Design of a Community Center in Batam Center Through Social Condenser Design Approach

Final Architectural Design Studio
International Undergraduate Program in Architecture

Mohd Rhafie Nadhif Nureski
21512164

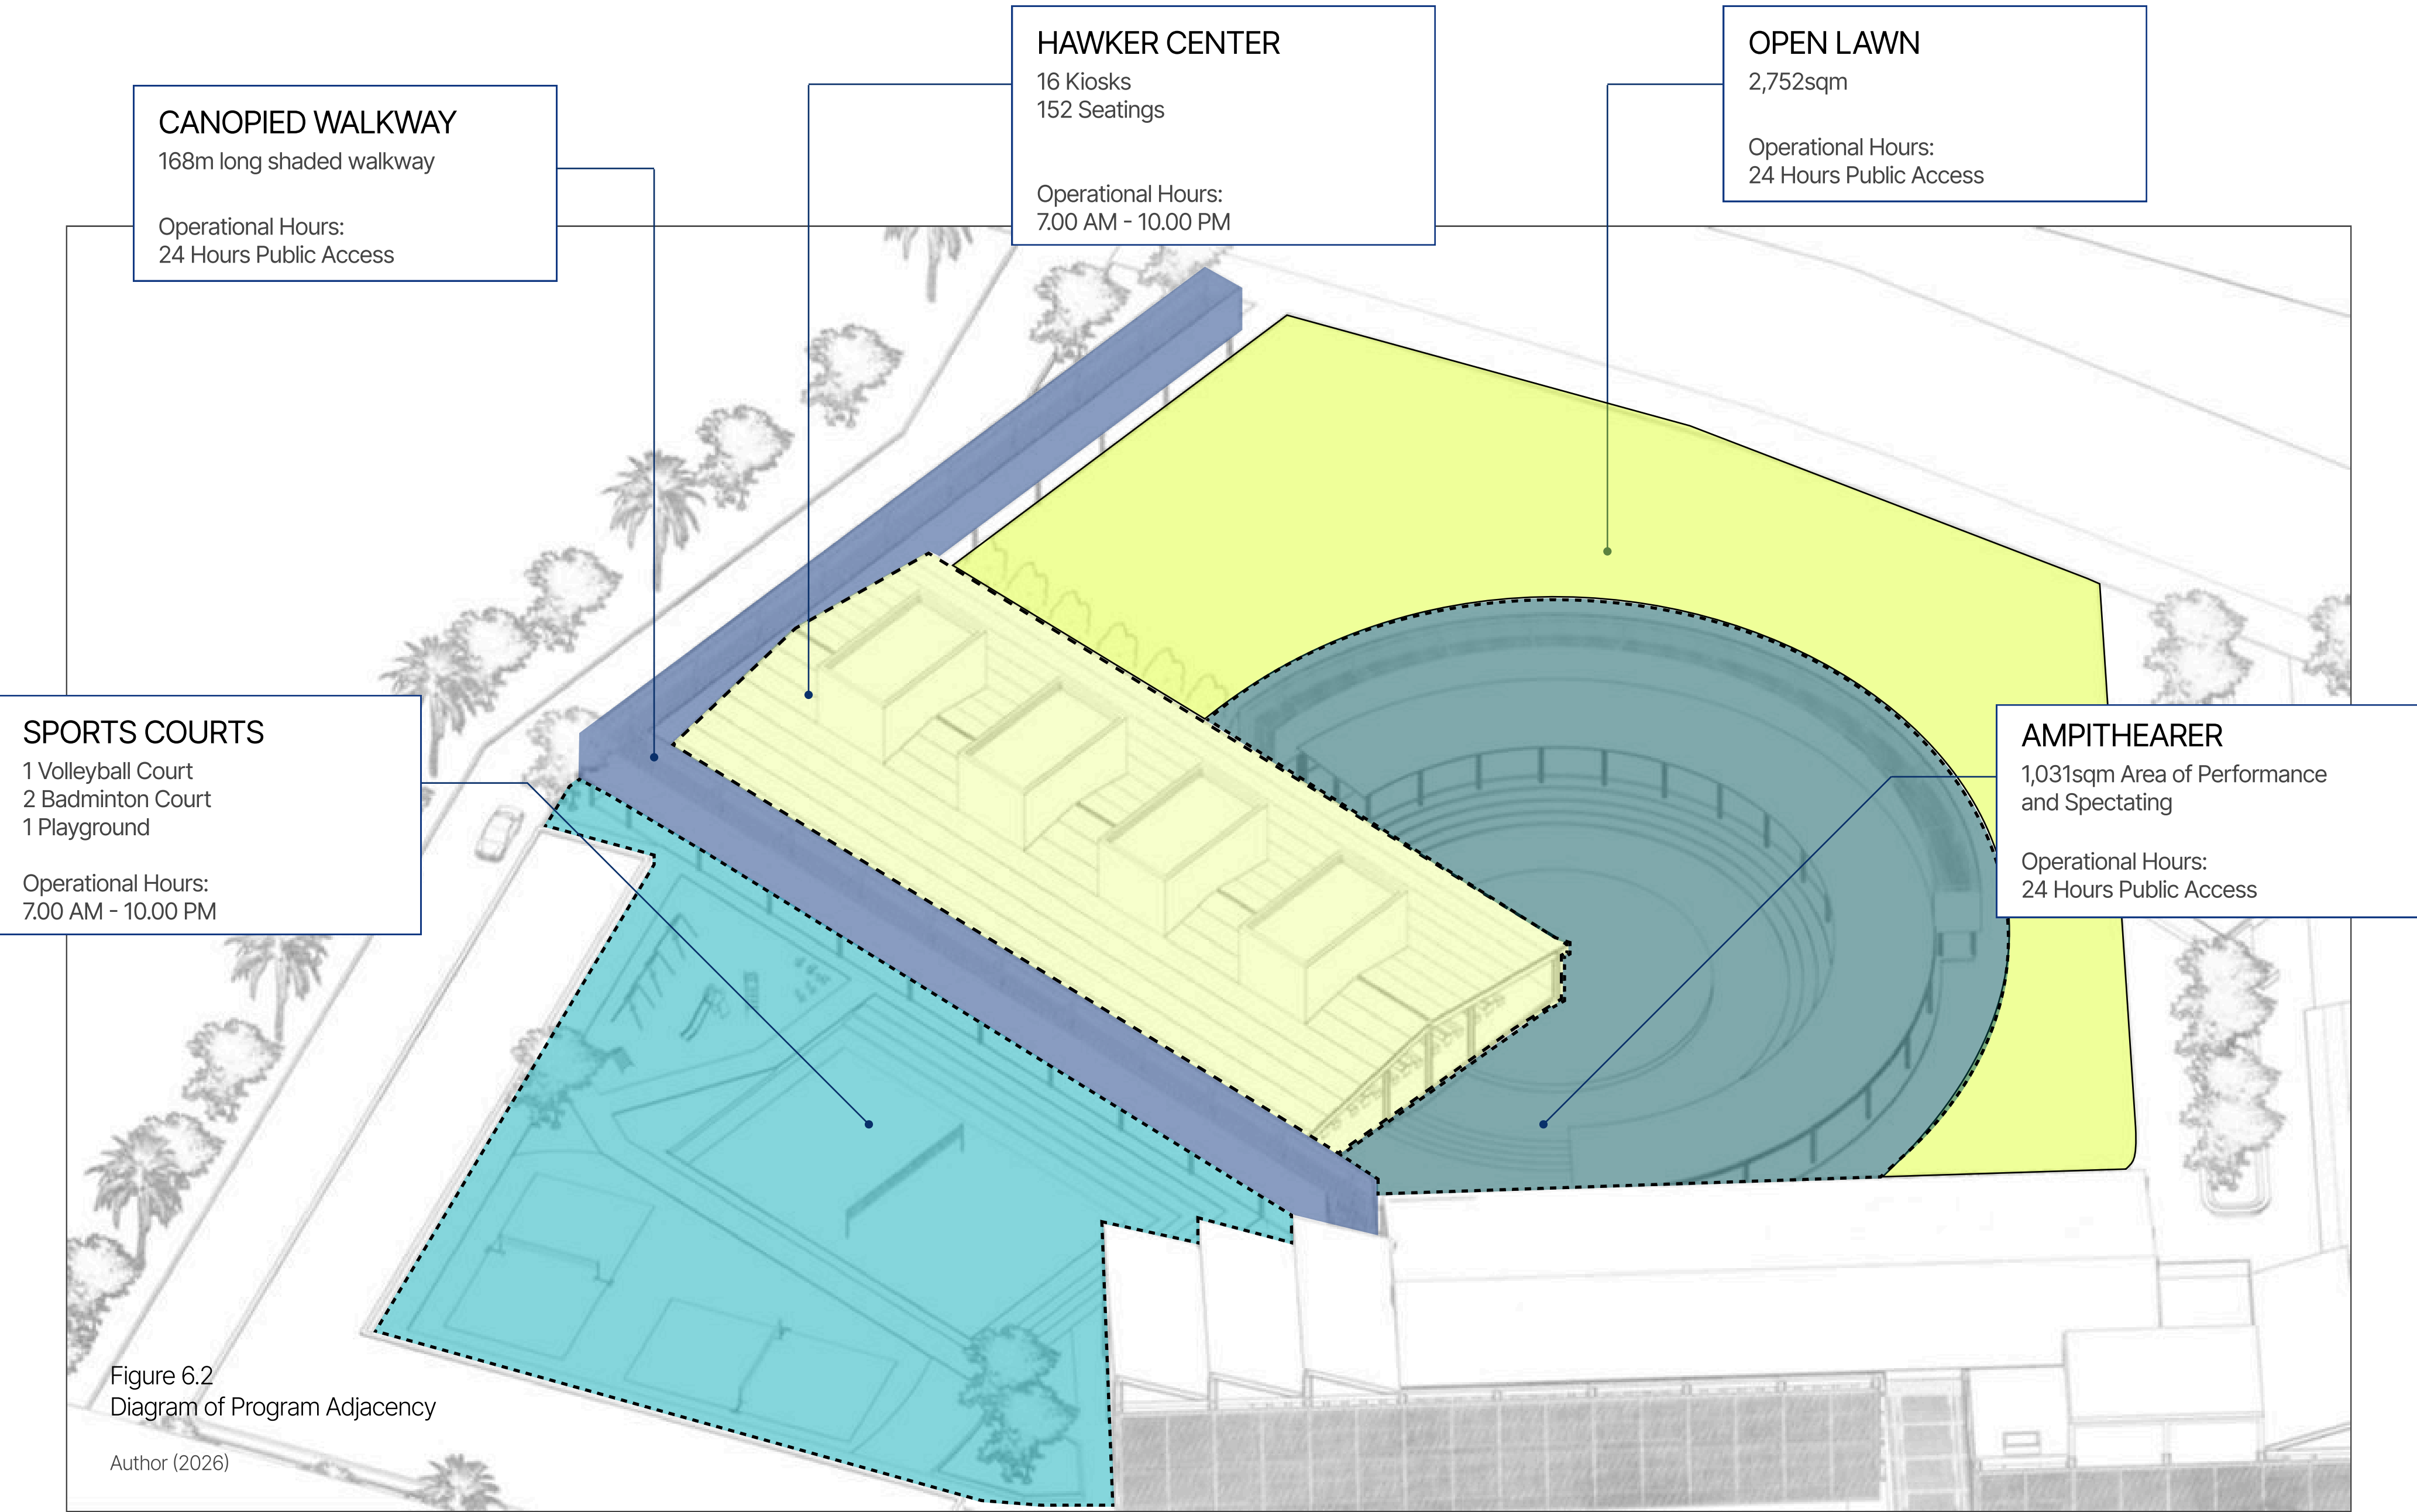
"Need to be more explicit on how the social condenser is being applied, such as 24 hours "clash of activities - cross social groups"

Figure 6.4
Before and after comparison of generator room's door and corridor
Author (2026)

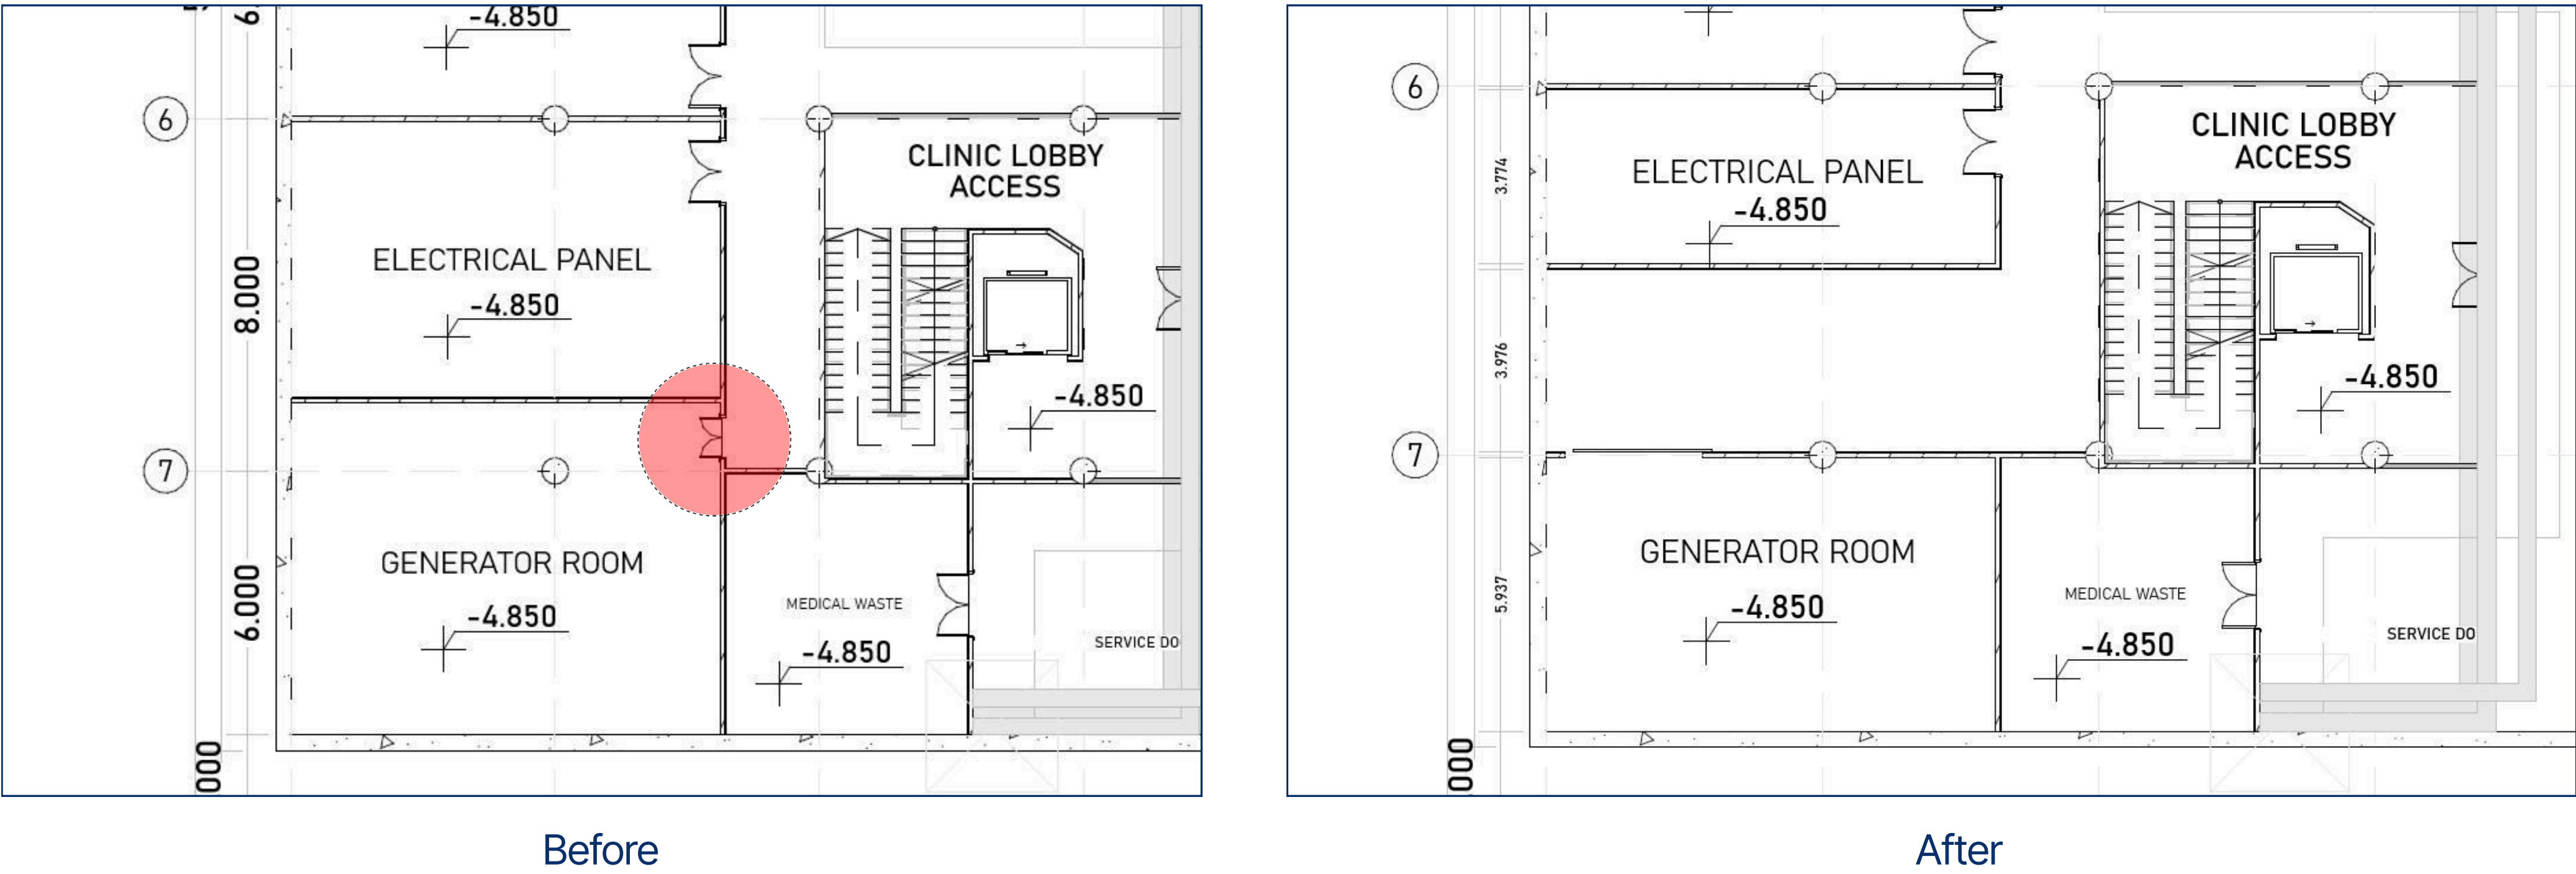
Comment from Jury 2
Dr. Ar. Yulianto Purwono Prihatmaji, ST., M.T., IPM., IAI.
“Access door to the generator room is too small”

The design **seen in figure 6.4** has been revised by increasing the access width to a 3000 mm sliding door, allowing adequate clearance for equipment delivery and installation. Additionally, a 3976 mm wide access corridor has been introduced to ensure smooth movement and turning radius for the generator during placement and maintenance operations. This adjustment improves functional feasibility and complies with equipment access requirements including the preferred specification of a 3,32 × 1,86 × 2,36m (100KVA) generator.
